**Re: Response to EPA Analysis of the *Final Habitat Mitigation and Monitoring Plan*, dated September 12, 2017, EPA Comments October 5, 2017 (Revised November 30, 2017)  
Rosemont Copper Project, Clean Water Act Section 404 Permit, CoE File No.: 2008-00816-MB**

## **RESPONSE TO ENVIRONMENTAL PROTECTION AGENCY (2017)**

**"The Mitigation Proposed by Rosemont Mine  
Will Not Offset Impacts to Waters of the U.S.  
below the Level of Significant Degradation"**

**Figure 7. Sinuosity Measurements on Big Casa Blanca Canyon****Figure 8. Existing Sonoita Creek Sinuosity Measurements**

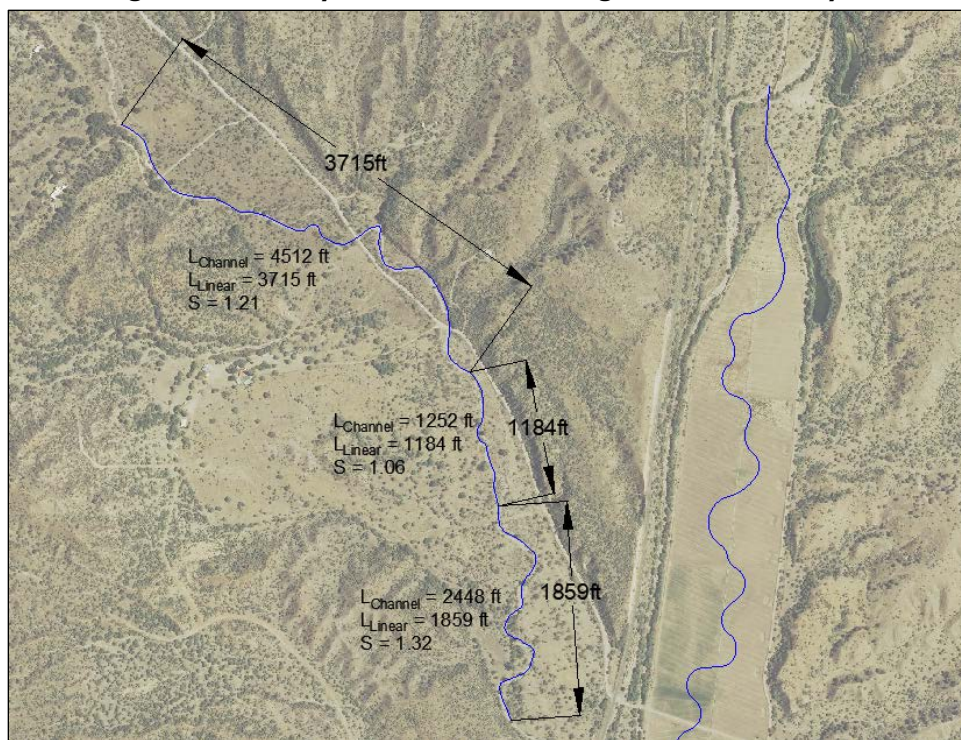
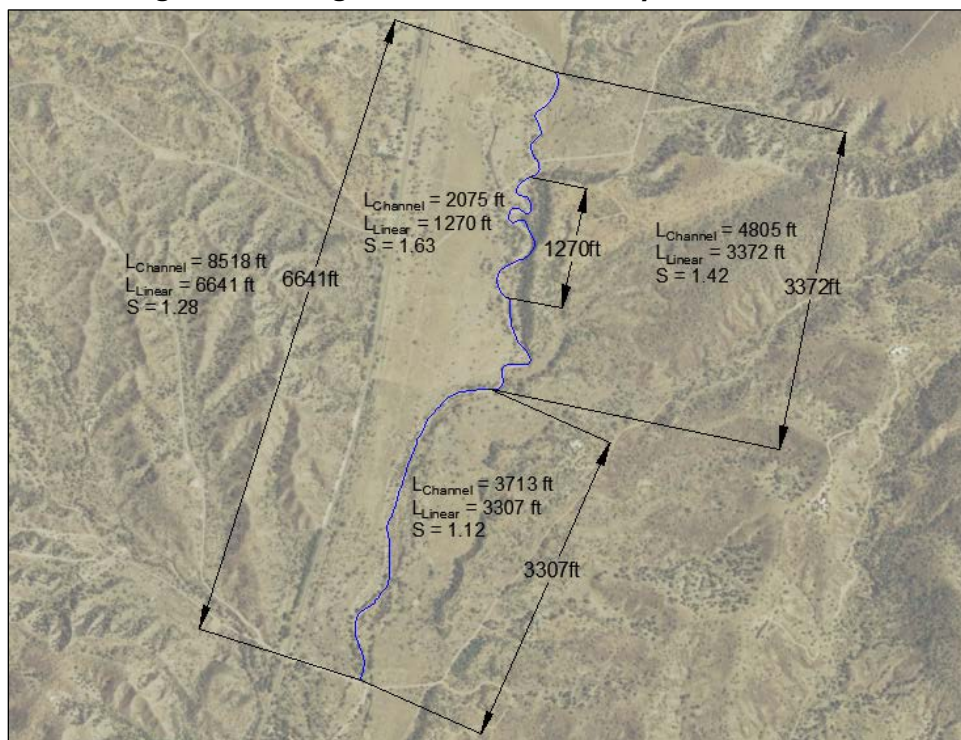
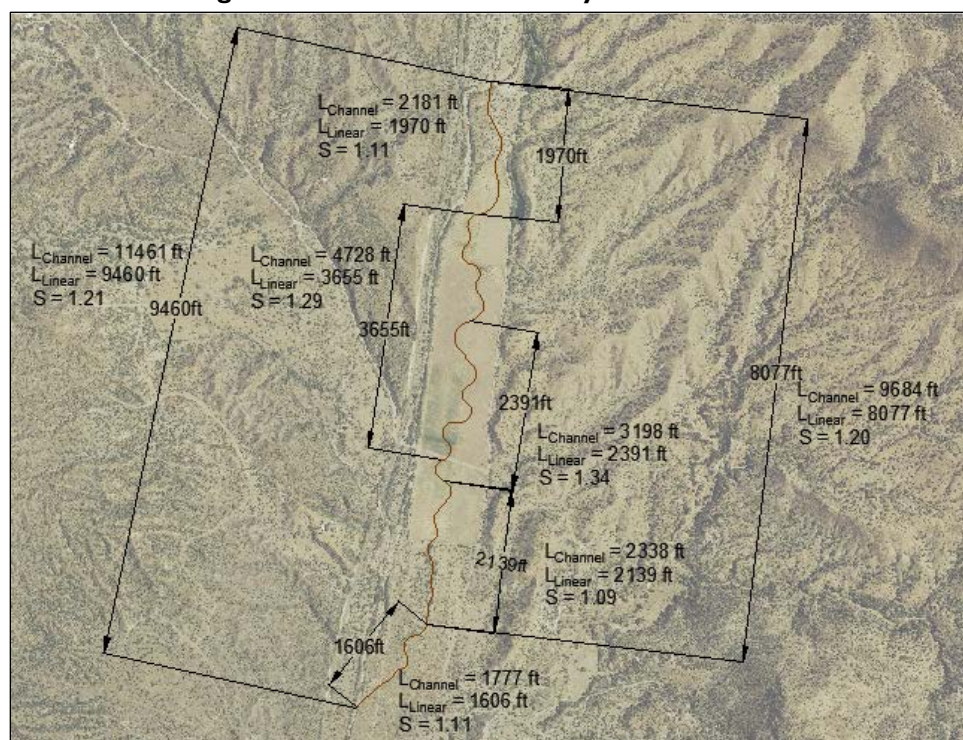
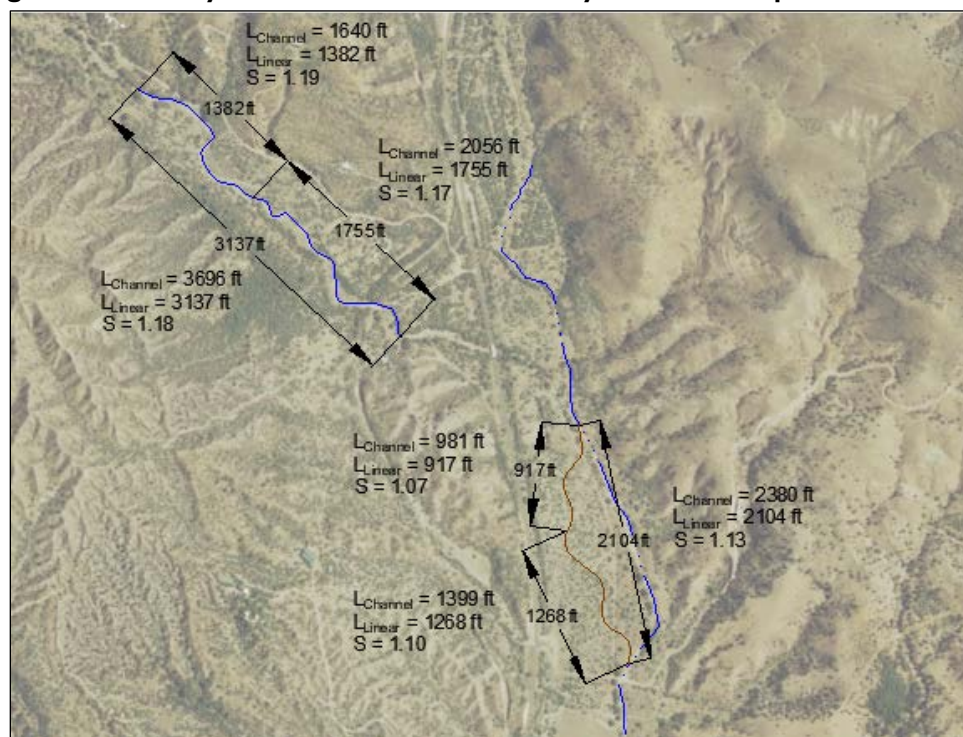
The EPA (2017) also argues that the proposed RX Channel was designed with excessively high sinuosity (1.15) to maximize mitigation credits, and implies that the high sinuosity is not sustainable.

More sinuosity measurements of the existing and proposed configurations of Sonoita Creek are presented for this response than in the HMMP, and they support the design sinuosity as proposed. The least altered, and most functional, dynamic reaches of Sonoita Creek and its tributaries, are not well represented by any single, uniform value of sinuosity, such as the 1.13 value presented by the EPA. Measured sinuosity of the proposed channels is within the measured range of sinuosity for the least-altered reaches of Sonoita Creek, Adobe Canyon, and Big Casa Blanca Canyon (**Table 1; Figures 7 through 10**). Average measured sinuosity of the proposed SCR Channel is 1.21, but the sinuosity measurements range from 1.09 to 1.34 (**Figure 9**), which is within the range of observed sinuosity for existing, functional and dynamic reaches of Sonoita Creek and its tributaries.

Another point in need of clarification is that the proposed channels are designed with compound form, including the dominant channel shape, and an active channel nested inside the overall channel form. Thus, the sinuosity for the inundated water surface (during a 5-year storm) is related to, but different than, the sinuosity of the active channel nested within the dominant channel. The dominant sinuosity corresponds to sinuosity of the centerline of flood inundation during the 5-year storm event. Both the RX and SCR channels are designed with compound channel geometry that includes floodplain benches that vary in width through the channel bends. For instance, on the inside of a bend, the floodplain bench width increases, and on an outside bend, the floodplain bench width decreases. The effect is that significant storm events with a flow depth greater than 2-feet deep will have a straighter, less sinuous flow path (**Figure 10**).

In response, we note that the sinuosity measured at Adobe Canyon is slightly higher than the proposed sinuosity of the RX Channel (**Figure 10**). EPA's sinuosity analysis included portions of Walnut Gulch between Flume 6 and Flume 2. However, it is inappropriate to include these portions of Walnut Gulch as reference reaches, as they are physically constrained and confined by local geology/topography and

**Figure 11. Dominant Channel Centerline and Active Channel Centerline****Figure 12. Sinuosity Comparison of Dominant Channel and Active Channel**

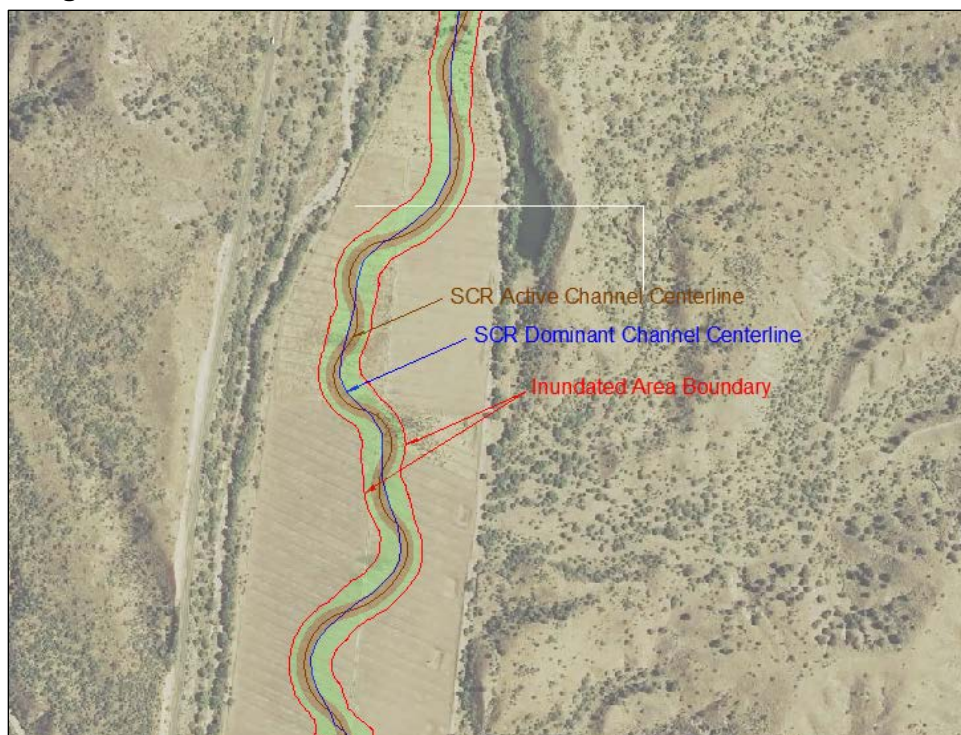
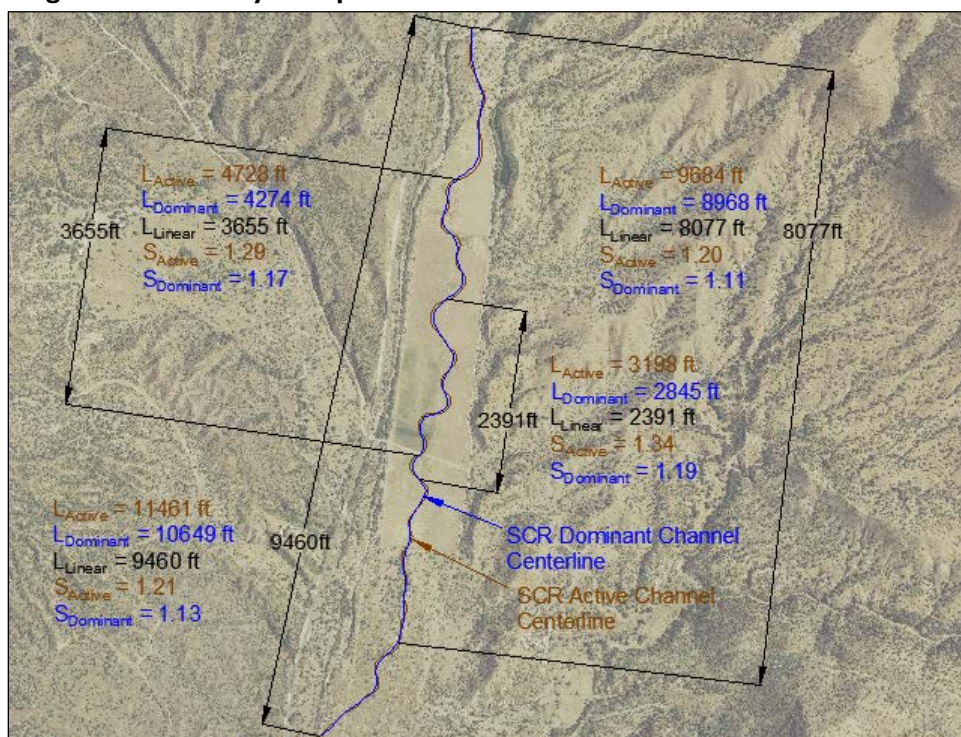
The inundated flow area (i.e., the 5-year flood area and the area for which mitigation acreage was calculated) will have a lower channel sinuosity than the active channel centerline. For instance, that reach of the SCR Channel with a sinuosity of 1.34 as measured from the active channel centerline has a lower dominant sinuosity of 1.19, and the overall measurement of the entire SCR Channel has an active channel sinuosity of 1.21, and a dominant sinuosity of only 1.13 (**Figure 11**). This approach demonstrates that sinuosity was informed by scientific and engineering principles rather than an attempt to maximize mitigation credit.

The proposed channel planforms are designed with multiple considerations rather than a single measure of sinuosity, and are supported by scientific considerations. The variable sinuosity proposed in the HMMP is better supported by onsite references than a uniform sinuosity value of 1.13 as suggested by the EPA. Furthermore, the dominant sinuosity measured from the inundated surface is 1.13 for the overall SCR Channel, which is equivalent to the sinuosity proposed by EPA, and was not maximized to gain additional mitigation credit.

**Figure 14. RX Ranch Agriculture Field and Leveled Topography**

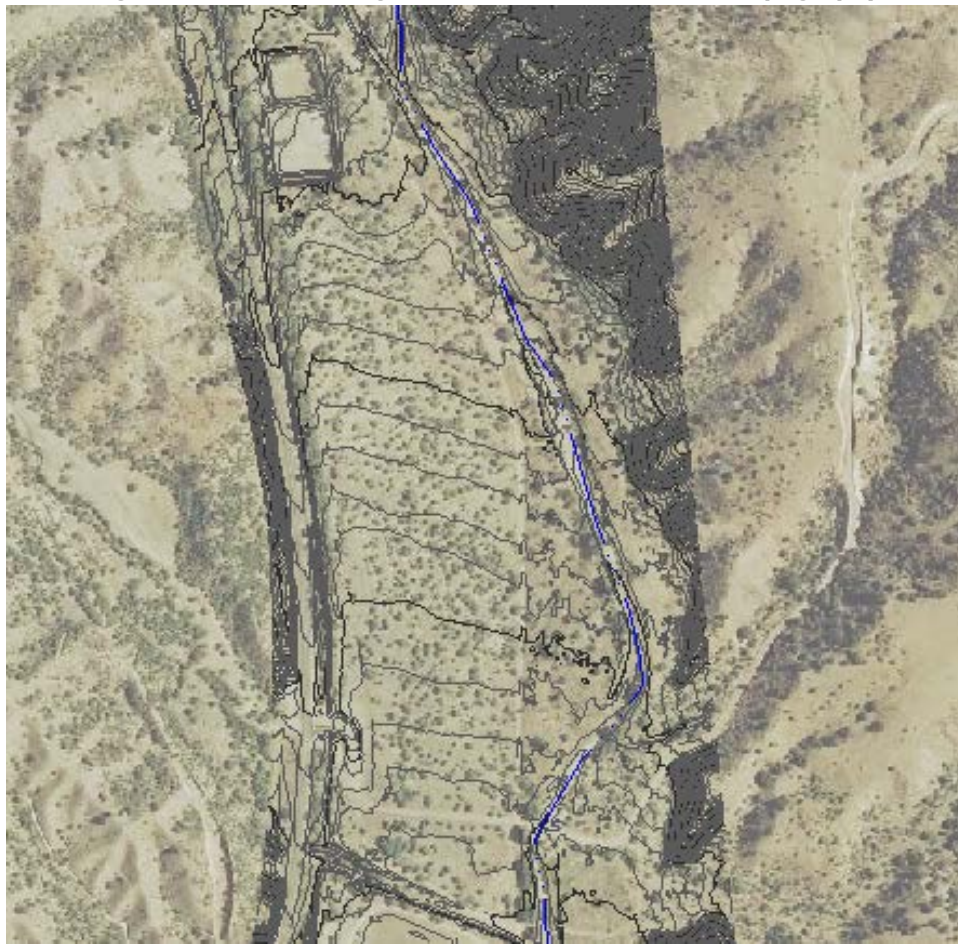
proposes that because the entire reach could be used as a reference reach, then there is no ecological benefit to realigning the channel.

At RX Ranch, clearly the valley bottom has undergone leveling activities and periodic cultivation. The parallel lines of topography at RX Ranch demonstrate the unnaturally uniform landform in this reach of the valley (**Figure 14**). There is considerable evidence of diversions and manipulation to Sonoita Creek at RX Ranch (**Section 2.3**). Currently, Sonoita Creek at RX Ranch is a straight reach with a single bend located on the east edge of the agricultural field. There is sufficient area within the agricultural field to reestablish Sonoita Creek and create a more sinuous, functional stream.

**Figure 15. Sonoita Creek Constrained Between Highway 82 and Gas Pipeline**

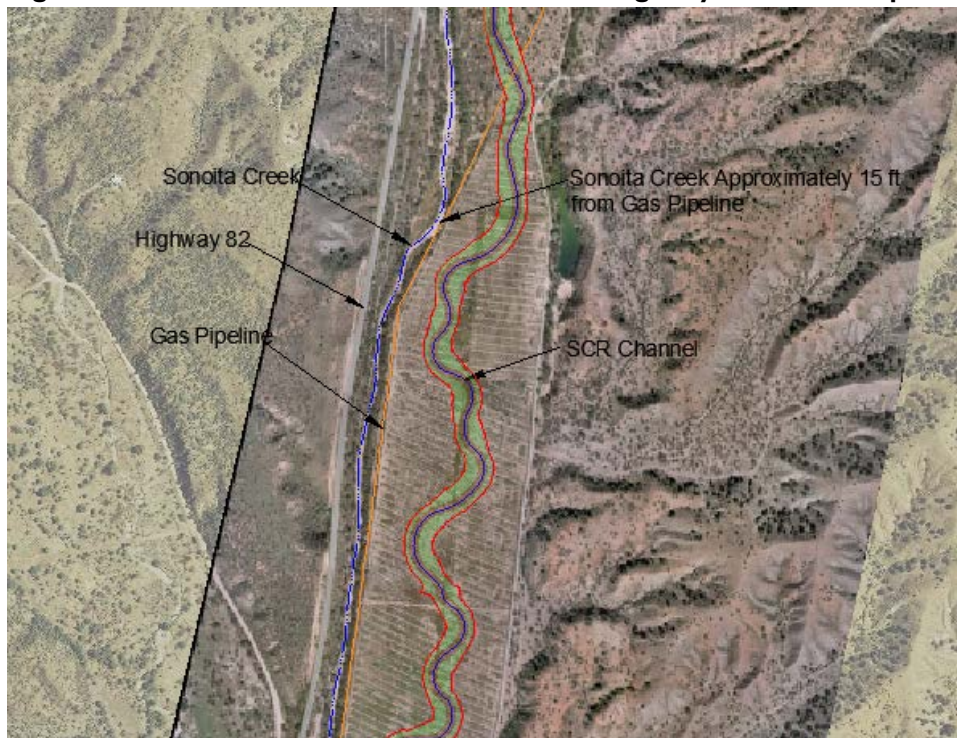
Finally, the EPA suggests that existing Sonoita Creek at SCR could be rehabilitated by excavating portions of the floodplain along its eastern bank.

This approach is not feasible at SCR because the gas pipeline is parallel to and in close proximity to the current eastern channel bank, in one case as close as about 15 feet (**Figure 15**). Furthermore, rehabilitating only the eastern bank would still leave in place the existing west bank, constrained by the highway and significantly manipulated and degraded by concrete channel walls and gabion baskets. The majority of the artificial armoring, which precludes channel migration or development as well as access to a functional floodplain, is located at the existing west bank at SCR.

**Figure 16. Bank and Buffer Rehabilitation at Lower Sonoita Creek**

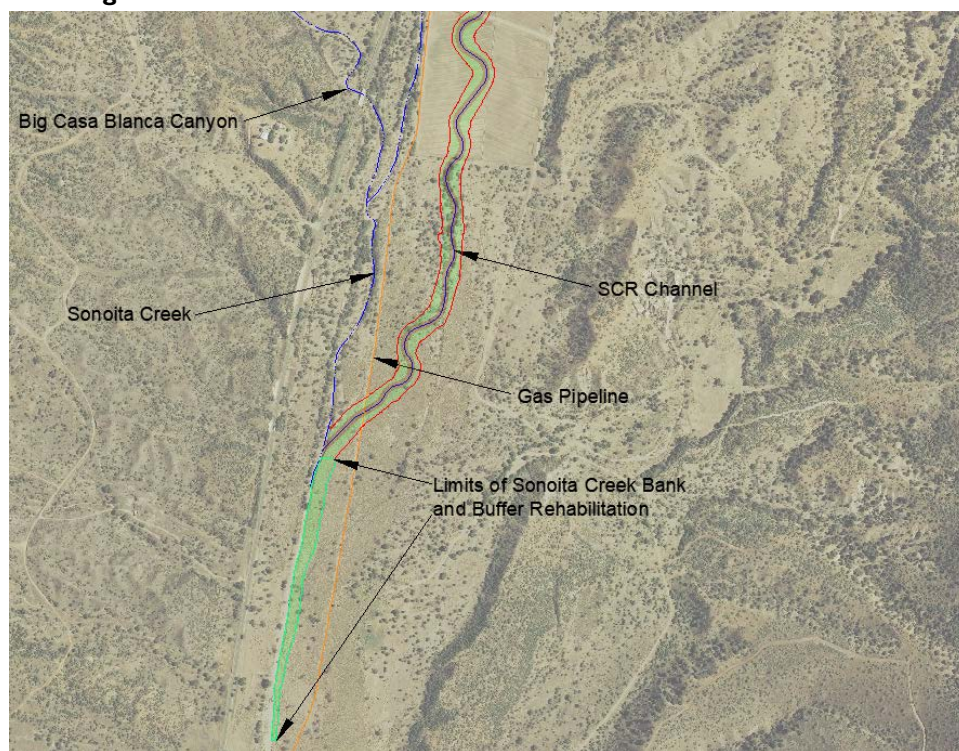
The EPA (2017) discourages the SCR mitigation project component that includes bank and buffer rehabilitation along the eastern bank of a reach downstream of the major channel rehabilitation reaches. The letter discounts channel bank sloughing and erosion as normal conditions and suggests that Sonoita Creek's channel banks be allowed to erode towards an equilibrium state characterized by a high-functioning floodplain.

This comment is notable in that it directly contradicts the EPA's comment in the immediate preceding paragraph, wherein they recommend rehabilitation along the eastern bank of the existing Sonoita Creek. Bank and buffer rehabilitation along the eastern bank is not practical for Sonoita Creek throughout the majority of SCR because there is not enough space between Sonoita Creek and the gas pipeline. However, bank and buffer rehabilitation is feasible along lower Sonoita Creek (as opposed to backfilling and replacing Sonoita Creek) because there is sufficient space, generally 330 to 350 feet, between lower Sonoita Creek and the gas pipeline (**Figure 16**).

**Figure 17. Effect of Elevated Roadway on Tributary Flowpaths**

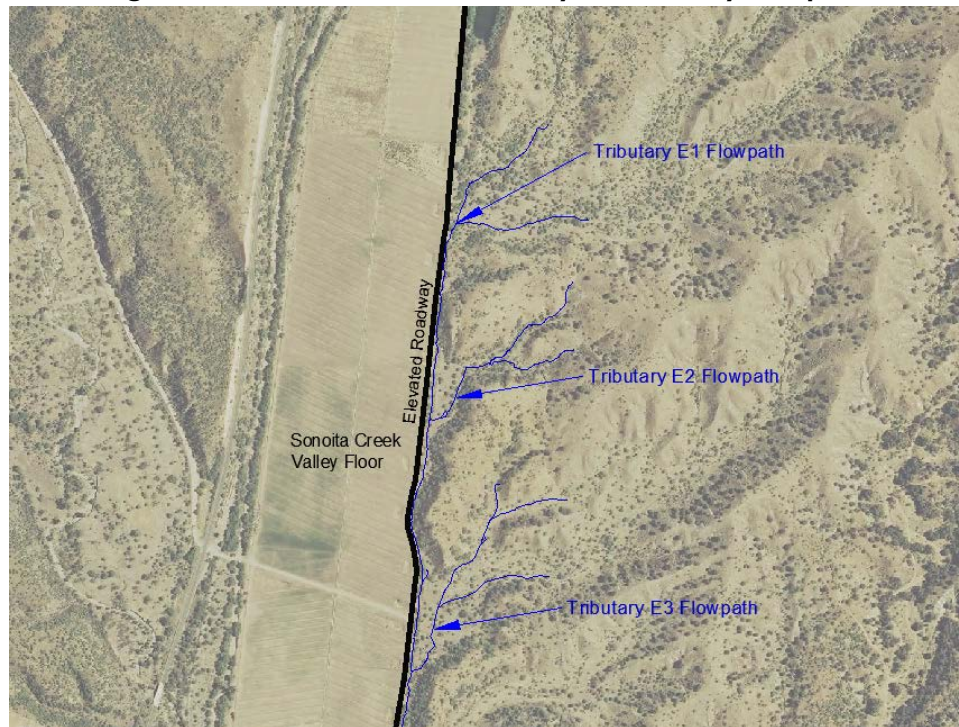
The EPA (2017) further asserts that the access road on the eastern edge of the agriculture field does not block the flows from the three tributaries. In response, we note that the access road was constructed as a linear fill across the eastern valley edge that is generally 4 to 5 feet higher than the existing terrain to the east. There are no culverts to convey discharge from the eastern tributaries under the road into the Sonoita Creek valley. The access road clearly interrupts flow and sediments from the three tributary channels based upon observations during field investigations (**Figure 17**). Sonoita Creek at SCR is a valley fill that was created as a result of sediments from the tributary watersheds being conveyed into and deposited on the valley floor. The HMMP proposal to reconnect the three eastern tributaries to the SCR Channel will reestablish natural continuity for stormwater hydrology and sediment transport into the Sonoita Creek valley. Furthermore, reestablishment of even small ephemeral drainages such as these will result in a more diverse and natural ecological condition. Therefore, reconnecting the three tributaries will provide substantial ecological benefit for the eastern side of the valley in that area.

The EPA (2017) finally states that there is not sufficient stream power to form a permanent bed and bank channel for the three tributaries. A defined bed is already observed where the roadway interrupts natural flow and diverts stormwater south along the road fill, and there are defined beds for each tributary upstream of the area where they currently terminate. It is speculative to suggest that the channel bed and bank features of the three reestablished connections to Sonoita Creek will recede over the long-term. Even if they do, eliminating the elevated roadway will reestablish the natural drainage pattern for stormwater and sediment to enter the Sonoita Creek valley with associated ecological benefits.
